REMARKS

The drawings , specification and claims have been carefully reviewed in the light of the Examiner's action.

FIG. 1

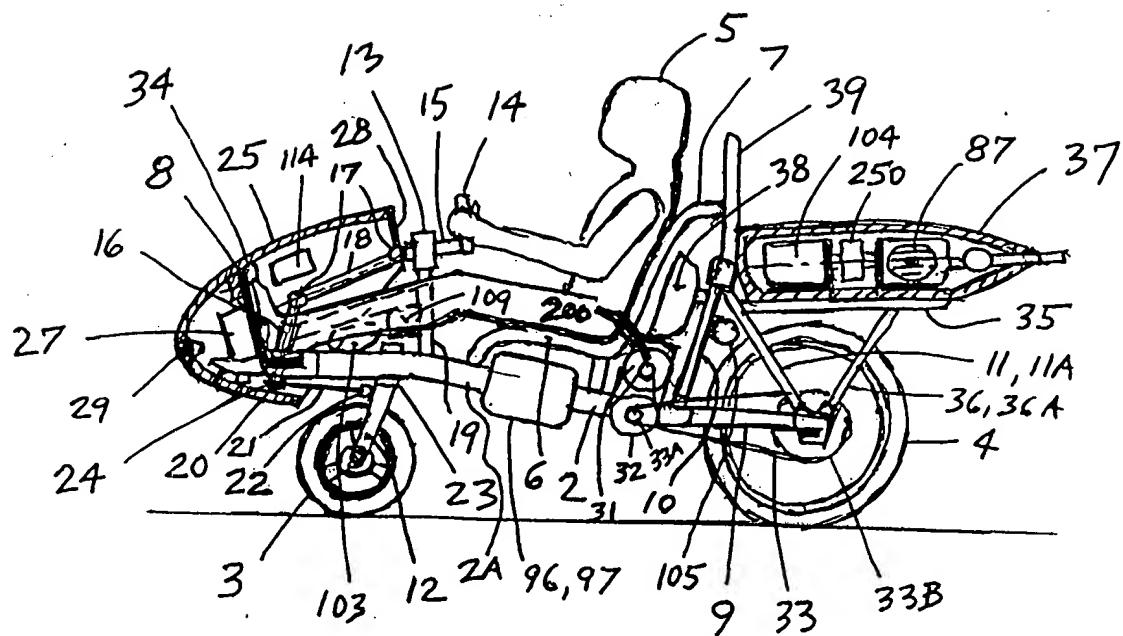
Drawing corrections have been made in Fig. 1 , Fig. 5 and Fig. 7 and highlighted in red ink per the Examiner's request. The specification was corrected per the Examiner's request for a minor error. Applicant agrees with the Examiner' correction on page 23 , line 5. No new matter has been added.
